EMF-52
Revision 7A

Consolidated License Application for
Framatome ANP, Inc. Model 51032-1
Shipping Container

Certificate of Compliance No. 6581
Docket No. 71-6581

Nature of Changes for Revision 7A

FIGURE 2.1 Model 51032-1 Vessel (Isometric View)

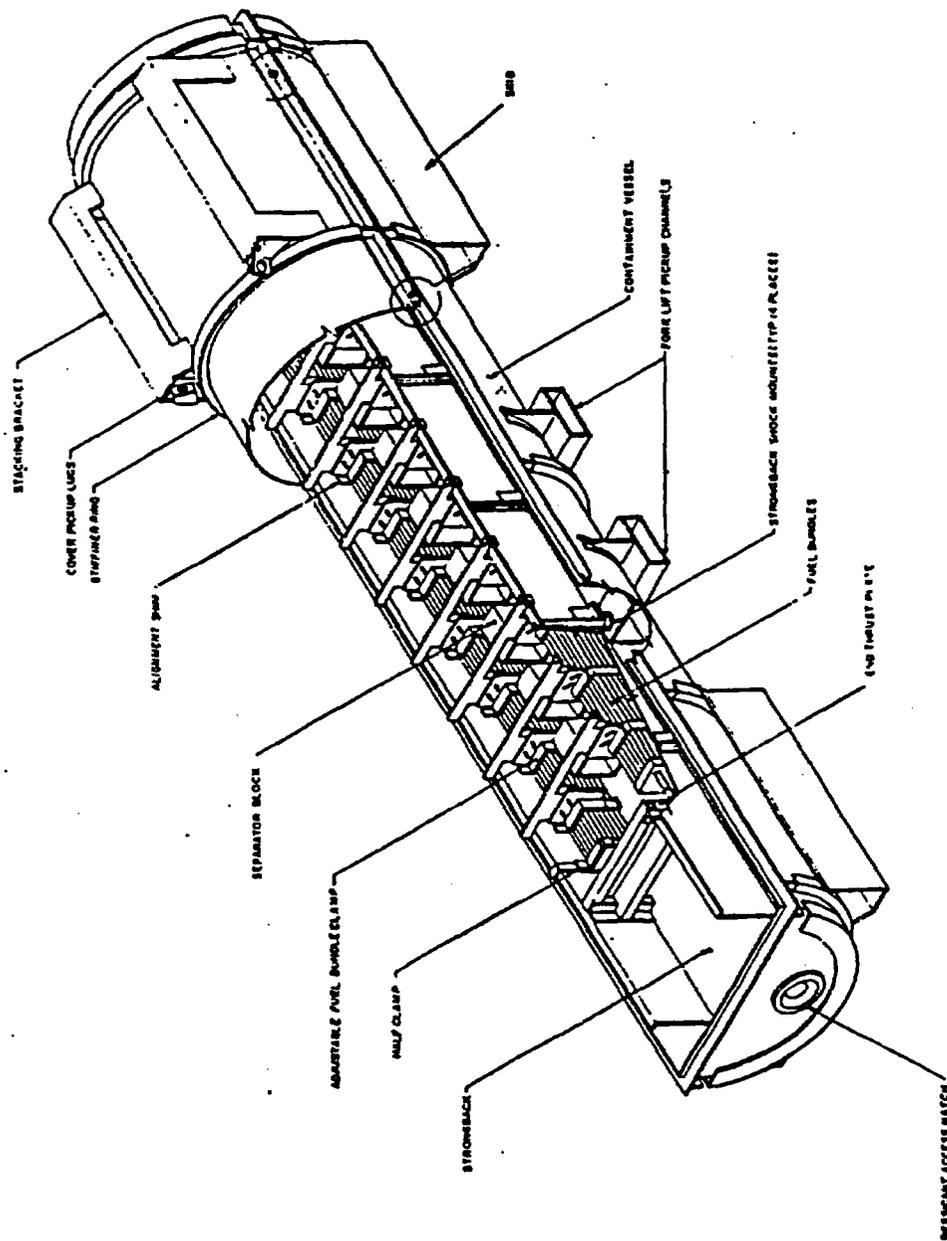
Item	Paragraph or Page(s)	Description and Justification
8.	Pages 2-11 to 2-18	<p>Added new Figure 2.1 and renumbered old Figures 2.1 through 2.6 to Figures 2.2 through 2.7 respectively. The sizes of the new Figures 2.2 through 2.7 were changed to 11" X 17".</p> <p><u>Justification:</u> New Figure 2.1 was inadvertently left out of Revision 7 of EMF-52. With the addition of Figure 2.1, the Figures now match the list of Figures in Table 2.1. The figure sizes were increased to make them more legible.</p>
